DOCUMENT CHANGE REQUEST

DCR number 489	Changes required for: General	Originator: S Jeffery - ESCC
Date: 2009/04/14	Date sent: 2009/04/14	Organisation: ESA/ESTEC
Status: IMPLEMENTED

Title:	Transistors Low Power NPN, based on type 2N3700		
Number:	5201/004	Issue:	3

ESCC Detail Specification No. 5201/004

1.6.1 Metal Can Package (TO-18) - 3 lead

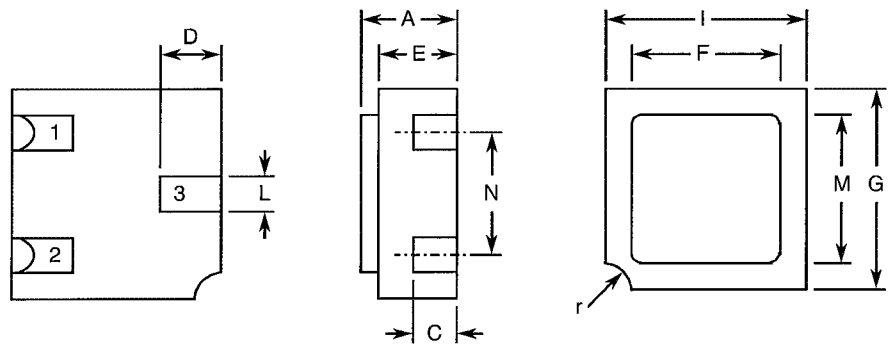
Note addition of horizontal lines

1.6.2 Chip Carrier Package (CCP) - 3 terminal

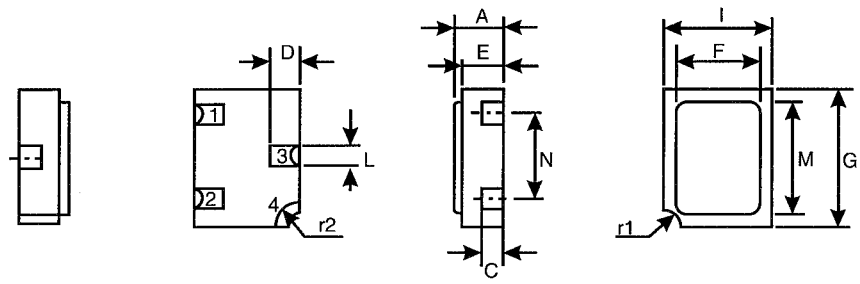
Note addition of horizontal lines
